Project #23-016
Iglesia de Dios Peniel Church
673 Riverwalk Parkway

Project Name: Iglesia de Dios Peniel Church
Proponent / Owner: Francisco Montufar / Iglesia de Dios Peniel, Inc
Project Address: 673 Riverwalk Parkway (620 South 180 West)
Request: Design Review Permit
Current Zoning: Traditional Neighborhood Residential (NR-6)
Type of Action: Quasi-Judicial
Hearing Date: March 9, 2023
Submitted By: Tanya Rice, Planner II

RECOMMENDATION

Figure 1: Proposed site plan

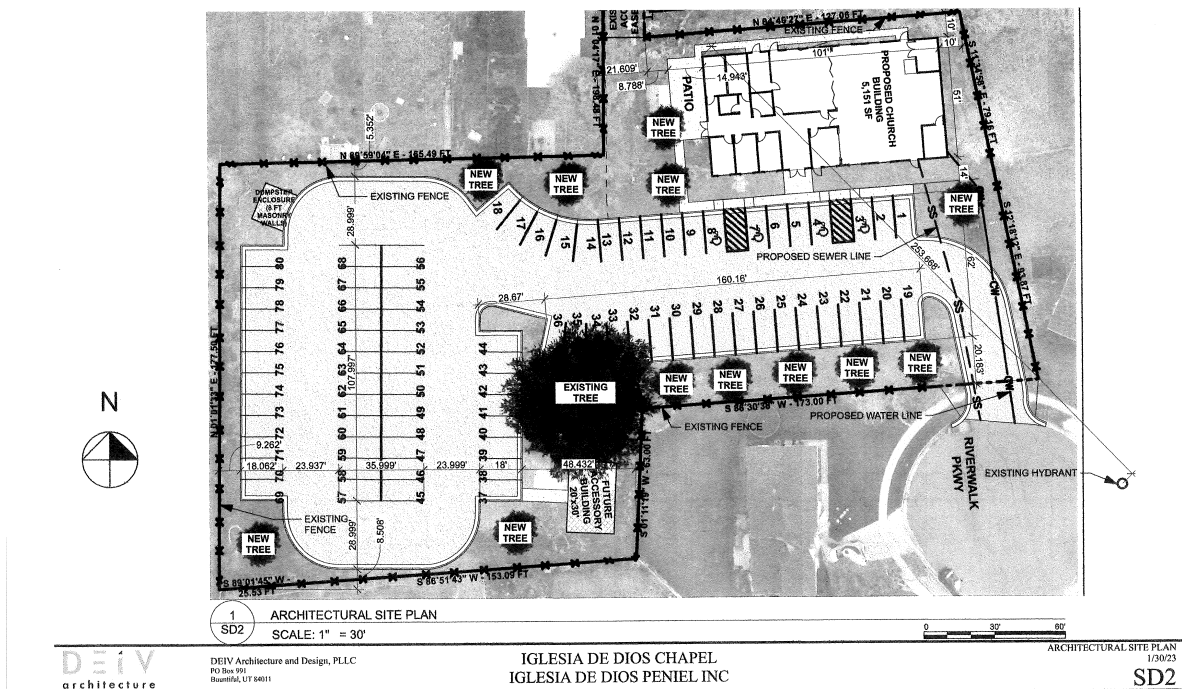
Based on 206 occupants and LDC parking requirements, a total of 52 stalls are required and 80 stalls are proposed. The LDC §17.31 allows for the parking standard to be exceeded by no more than 25%. The proposed 80 parking stalls exceed the requirement by 53%. With the 25% increase, the maximum number of parking stalls authorized by the LDC for this size and type of use is 65 stalls. In this specific case, because the proposed church is surrounded on three sides by existing residential dwellings, additional open space and landscaping is important to buffer the parking lot from the neighbors. As conditioned, the parking count shall be reduced to a minimum of 52 stalls up to a maximum of 65 parking stalls.

The LDC also requires one (1) bicycle stall for every 30 vehicular stalls. As conditioned, bike parking shall be provided on site.

The LDC §17.32 requires 20 trees and 50 shrubs per one (1) acre of gross land for new development (30 trees and 74 shrubs). A minimum of 25% of landscaping is required to consist of evergreen trees and shrubs to provide visual interest year-round and for dense landscape screening. Plant material shall be placed around the perimeter of the building footprint in a three (3) foot minimum planting strip except for entrances, utilities and where setbacks are less than three (3) feet. The proposed site plan shows twelve (12) new trees around part of the perimeter of the property and a patio on the west end of the building. A landscape plan shall be submitted showing additional landscaping concentrated around the perimeter of the property to provide privacy and mitigate sound. As conditioned, the landscaping sufficiently meets the requirements of the LDC.

The LDC 17.37.090 requires adequate lighting that adds aesthetic quality and improves safety while mitigating unnecessary glare, sky glow and light trespass. The LDC limits freestanding pole height to 32 feet and luminaire fixtures on buildings and canopies to be concealed source, down-cast and shielded from neighboring properties. Light measurements are required to range between 0.5 – 4.0-foot candles, so areas are sufficiently safe, but not excessively bright. As submitted, no exterior lighting has been shown. As conditioned, the project meets the requirements of the LDC.

5. A minimum of 52 parking stalls shall be provided. With a 25% parking increase, a maximum of 65 is permitted.
6. A bicycle rack shall be provided and shall meet the requirements of the LDC §17.31.040.

Figure 2: Front façade facing south

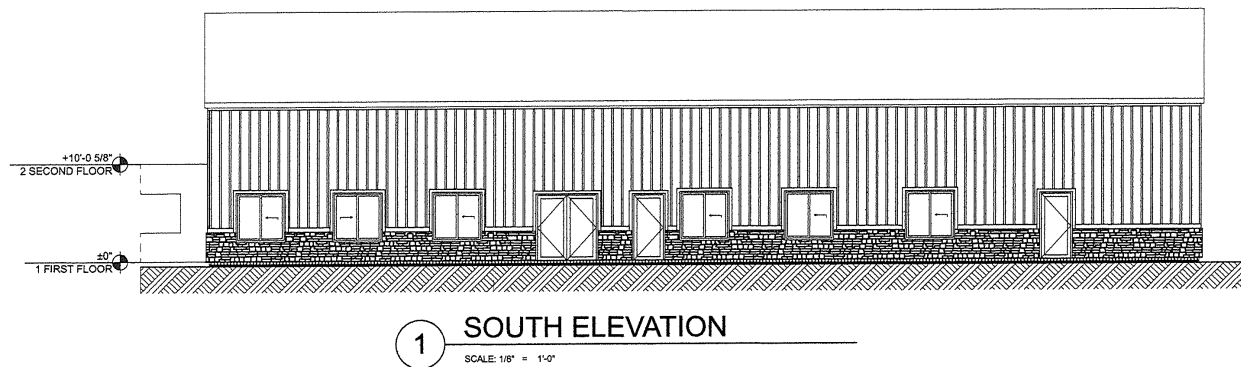
The dominant building material is metal siding with stone veneer wainscoting around the base perimeter. The front of the building is oriented to the parking lot and is approximately 28' high at the peak of the gable, well within the 35' maximum requirement in the NR-6 zone. The proposed building shows consideration of transparency (fenestration) on three sides. There are seven (7) entrances to the building: three (3) on the south (front), three (3) on the north (rear), and a double door on the west. Per general design standards and pedestrian protection, each entrance shall have overhead entrance protection above each doorway. As conditioned, overhead entrance protection above each doorway, the building design meets LDC standards for NR-6 zone.

3. Provide overhead entrance protection to all pedestrian entrances on the building.
4. A landscape plan, prepared in accordance with §17.32 of the LDC, shall be submitted for approval to the Community Development Department prior to the issuance of the building permit. The plan shall include the following:
